Access Compliance Report

Public Rights-of-Way

(Curb Ramps)

Intersection ID: 28193	Main Street: MARVIN_RD	Cross Street: JOHNSTON_RD	Location: SE
ADA ID: 2B76EC594AB2	Ramp Type: BlendTrans2	Initial Pass/Fail: Pass	Overall Compliance: No
Severity Score: 0			
Codes/Mitigation Info/Possible Solution		Field Measurements/Component Compliance

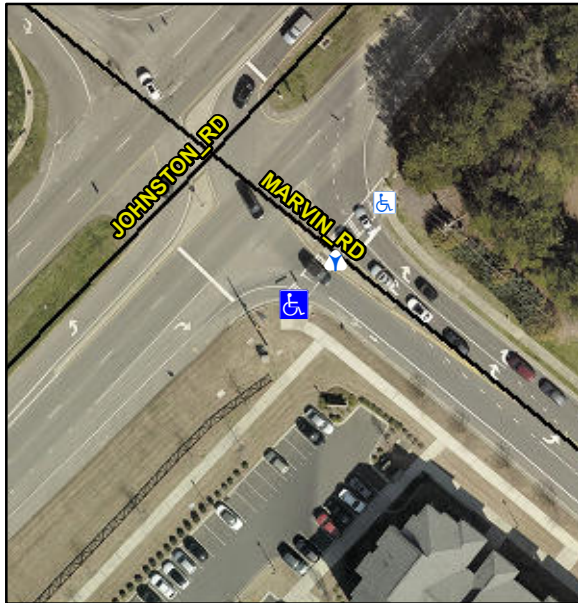
Remove & Replace Curb Slope and Extend Ramp.

Yes	Ramp inside XWalk1?	Yes	N/A	Ramp inside XWalk2?	N/A
	Road Slope (%)	1.8		Clear Space?	Yes
	Road X Slope (%)	2.5	N/A	Clear Space to XWalk (in)	N/A
Yes	Any Obstructions?	No	Yes	Storm Grate/Utility Hazard?	No
	Obstruction Type			Storm Grate/Utility Type	
		N/A			N/A
			Yes	Surface Condition? (G/P)	Good
			No	Curb Slope (%)	9.5
